From: [Owen Trepanier](#)
To: [Vanessa T. Sellers](#)
Subject: RE: 2407-2409 N Roosevelt Blvd
Date: Friday, May 10, 2019 11:17:21 AM
Attachments: [image001.png](#)
[01 - Concurrency Revision 05-10-19.pdf](#)

From: Vanessa T. Sellers <vsellers@cityofkeywest-fl.gov>
Sent: Friday, May 10, 2019 8:32 AM
To: Owen Trepanier <owen@owentrepanier.com>
Subject: 2407-2409 N Roosevelt Blvd

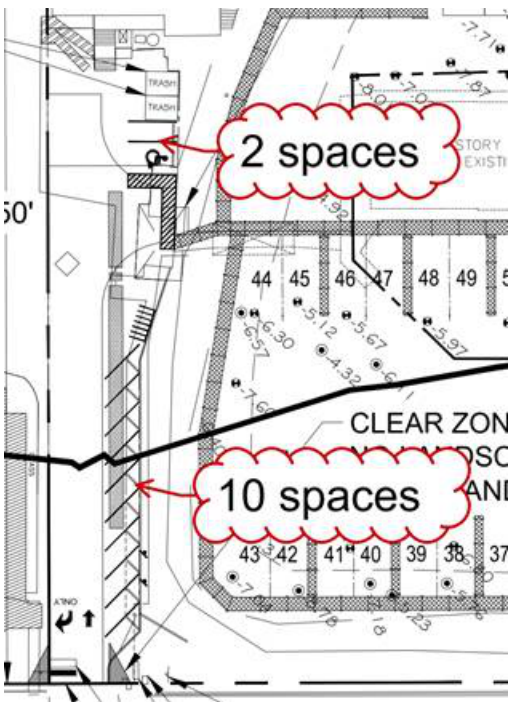
Plan C-1.0 site data table states there are 32 existing auto spaces, however, I only see 31 delineated spaces.

Also, are these standard-sized stalls? There are no dimensions provided. Previous plans showed 13 compact spaces running along the driveway. I am asking because if some are compact-sized I need to incorporate language for the modification to be approved by the city commission (section 108-641).

32 Spaces - Yes. The plan lists 32 spaces (12 on site). The plan shows 12 onsite (see below). Onsite spaces were reduced from 17 to 12, based on our meetings with you and Pat where increasing parking = increased capacity which triggers 108-571, and specifically, 108-575(5). The room for the additional spaces is still there in the design. So if the Dept and/or the PB believes keeping them doesn't trigger 108-571 & 108-575(5), and the Dept or PB wants them, we have no objection.

Parking Stalls – The angled spaces are 7.5 x 18 and previously approved. However, we are rearranging the parking slightly from the existing approval. The rearrangement is what allows for the potential increase of 5 spaces. In that specific area (the angled parking), the approved design has 9 angled spaces. The current proposal has 10. Since its changing from the existing approval, I would guess we need to deal with the Modification provision. Thanks for catching that.
